UNITED STATES PATENT AND TRADEMARK OFFICE

APPLICATION NO.	FILING DATE	FIRST NAMED INVENTOR	ATTORNEY DOCKET NO.	CONFIRMATION NO.
09/889,895	07/24/2001	GERALD ANTON OFNER	046-7001.30	3043

Office Action Summary	Application No.	Applicant(s)	
	09/889,895	OFNER, GERALD ANTON	
	Examiner	Art Unit	
	Lee Fineman	2872

DETAILED ACTION

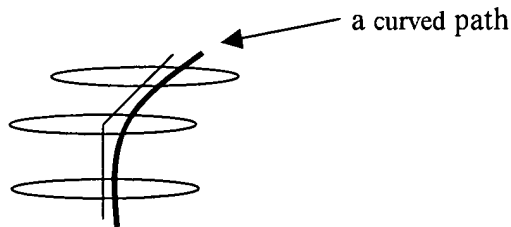
Applicant argues that because the cam path in figs. 4A and 4B of Kato has an angle that it cannot be considered a curved path (see remarks page 15, lines 3-11). The examiner respectfully disagrees. The claims are not limited to requiring the center or any other particular single portion

of the optical element to move along a curved path, nor are they limited to a curved guide groove defining the curved path. Thus a curved path may be defined as illustrated below, which Kato's element follows, when traversing the path produced by the moving arrangement shown in figs. 4 and 5.
